**Subject: Class 1 Permit Modification Request to Add a Universal Drum Assay and Segregation System and Hydraulic Power Supply Unit at Technical Area 54, Area G, Pad 11 for the Los Alamos National Laboratory Hazardous Waste Facility Permit, EPA ID No. NM0890010515**

April 2023  
EM2023-0144

**Class 1 Permit Modification Request to  
Add a Universal Drum Assay and  
Segregation System and a New  
Hydraulic Power Supply Unit at  
Technical Area 54, Area G, Pad 11 for  
Los Alamos National Laboratory  
Hazardous Waste Facility Permit,  
EPA ID No. NM0890010515**

Figure G.12-1: Technical Area 54, Area G, Pad 11 Outdoor Container Storage Unit Grid Sampling and Additional Sampling Locations

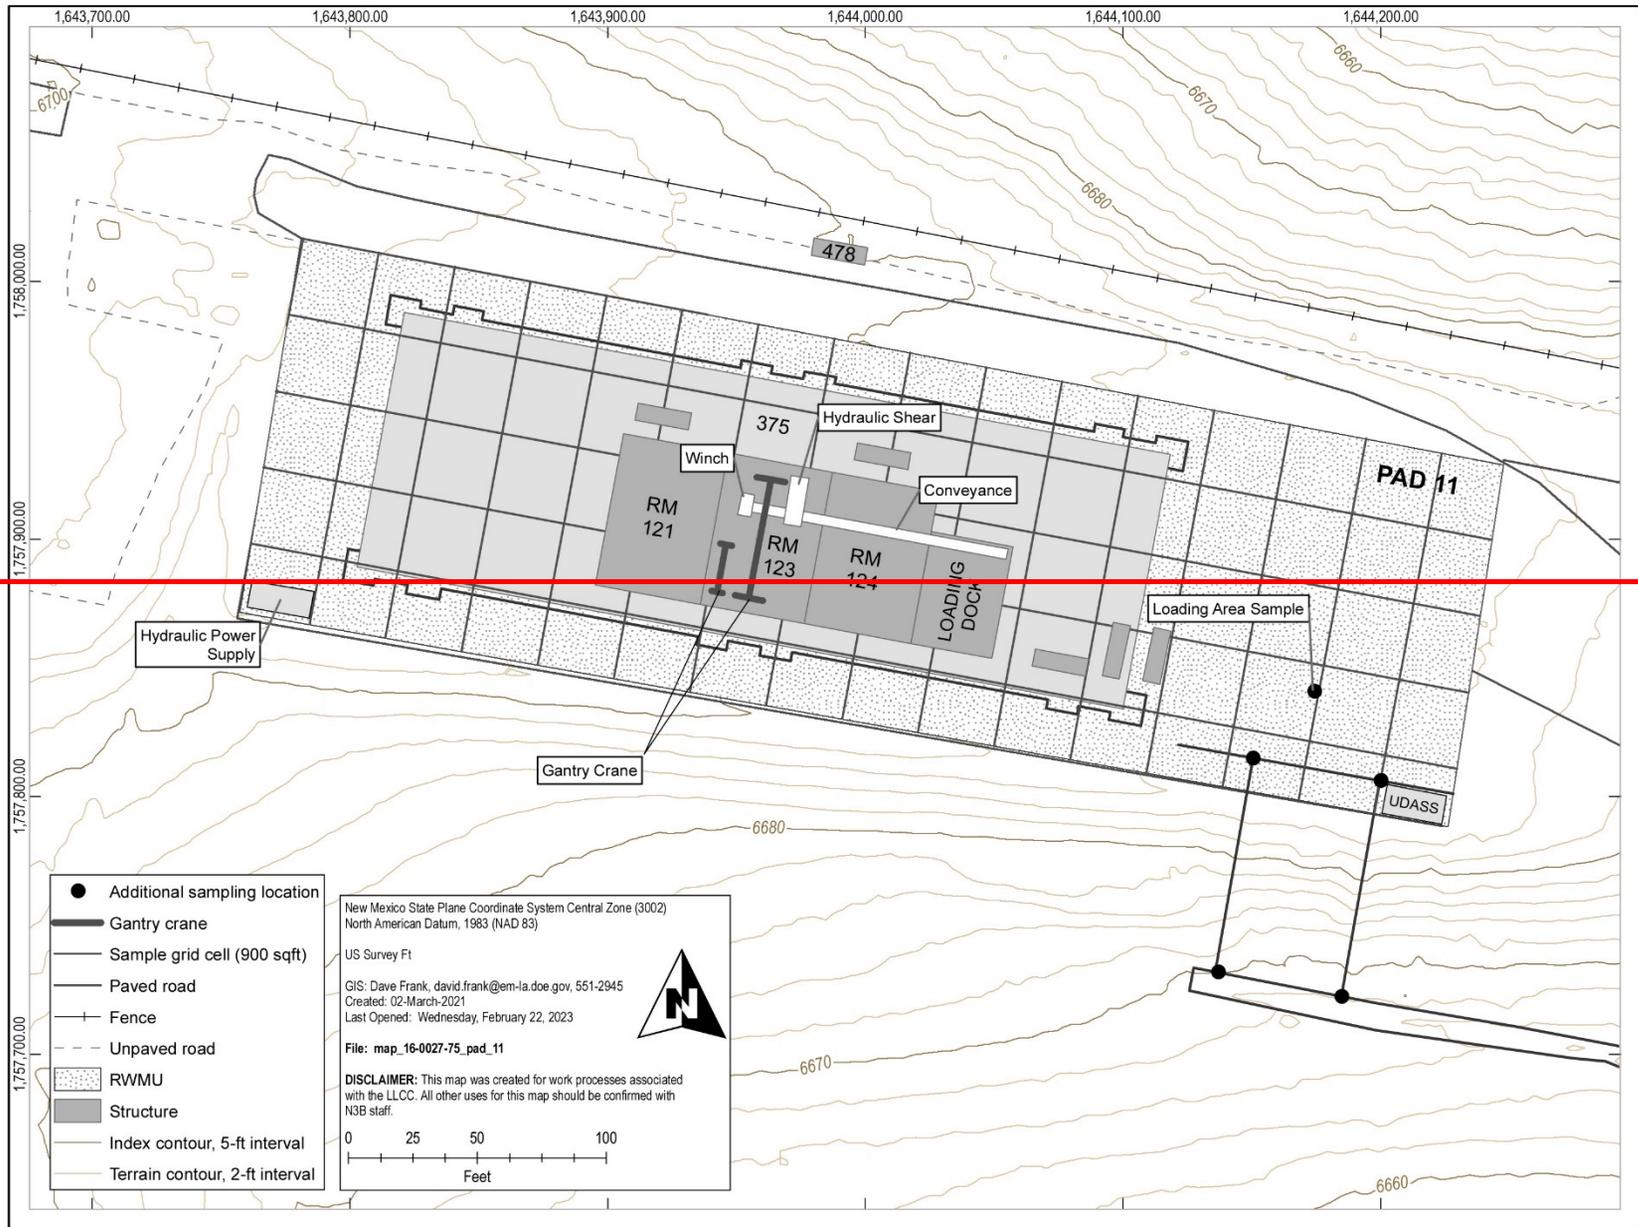
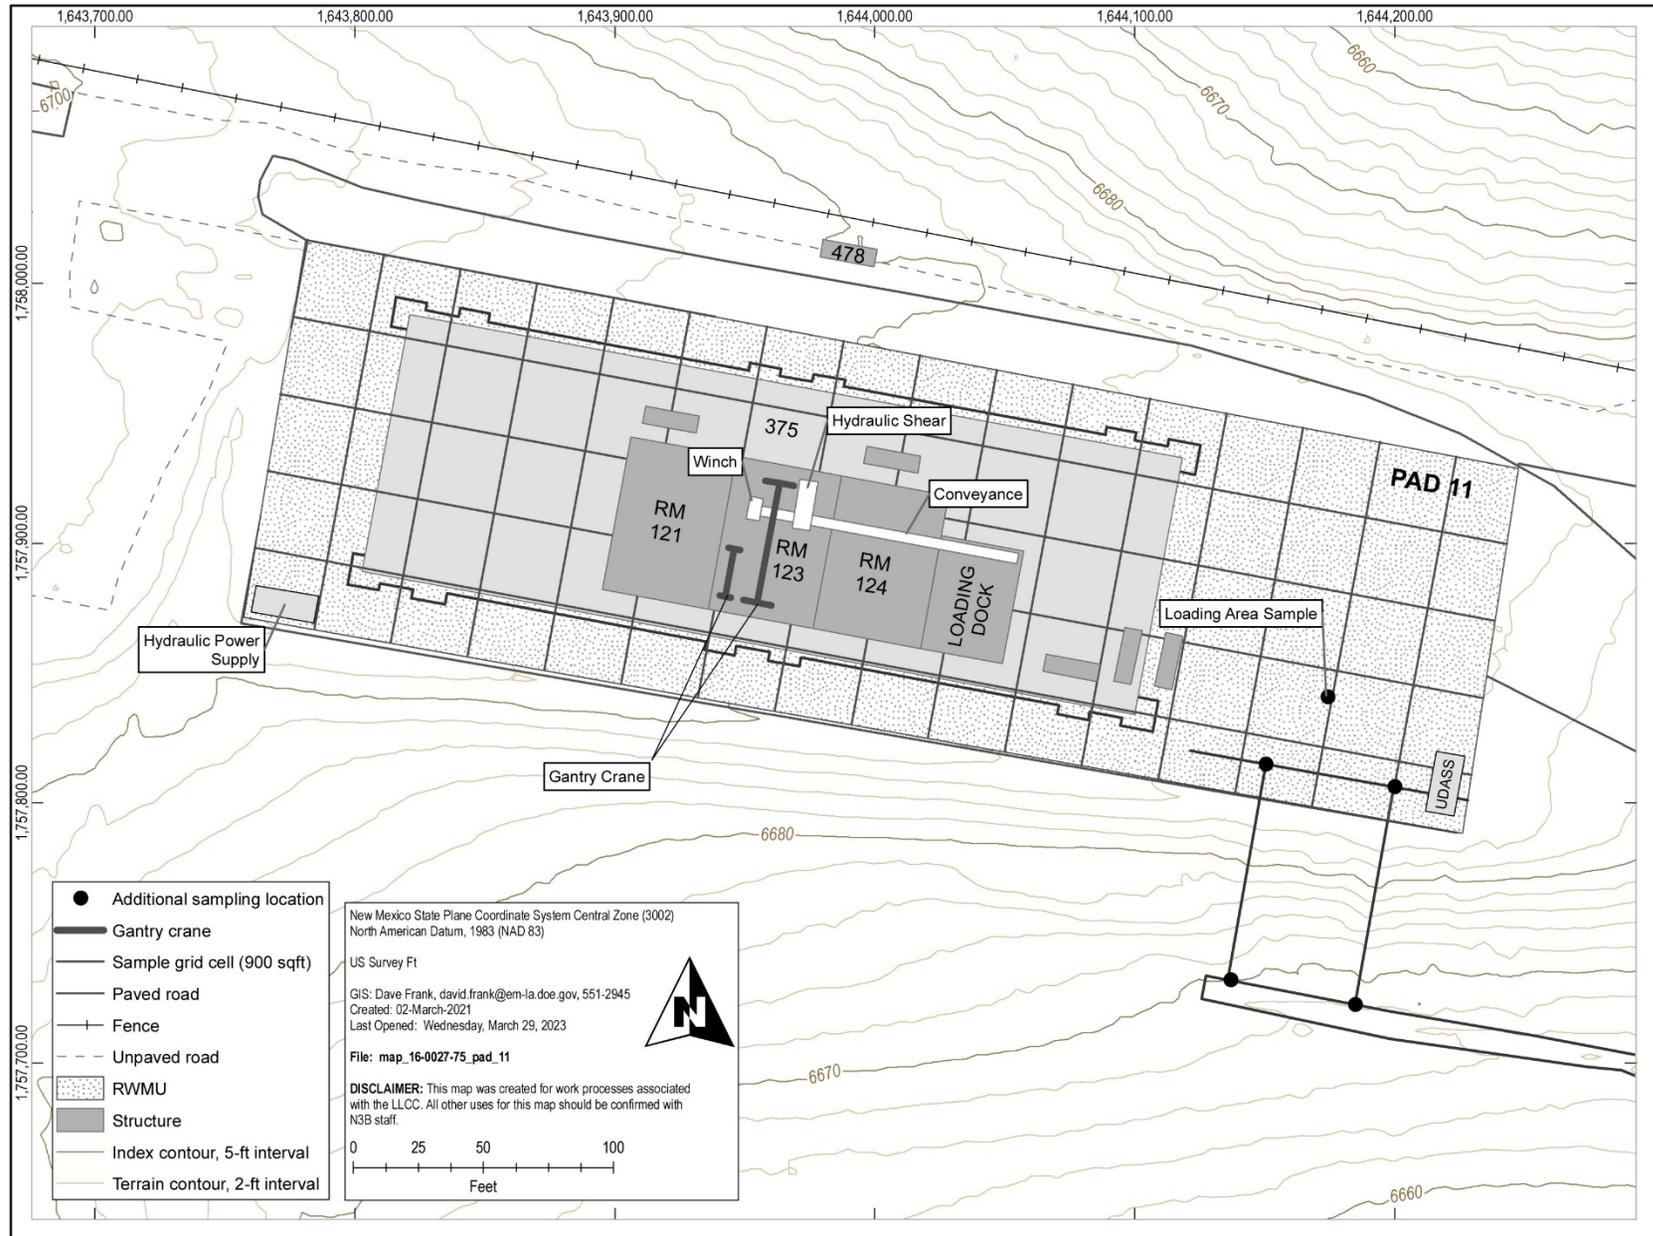
- Attachment A, Technical Area (TA) - Unit Descriptions (changes shown in redline). Language was added to Section A.4.2.9 describing the UDASS and HPS at Pad 11.
- Attachment G.12, Technical Area 54, Area G, Pad 11, Outdoor Container Storage (changes shown in redline). This attachment also includes the revised Figure G.12-1.
- Revised Figures (Attachment N, Figures 27 and 36, and Figure G.12-1). Figures 27 and 36 were revised to show the UDASS and HPS on Pad 11. Figure G.12-1 was revised to show the location of the UDASS and HPS on Pad 11.
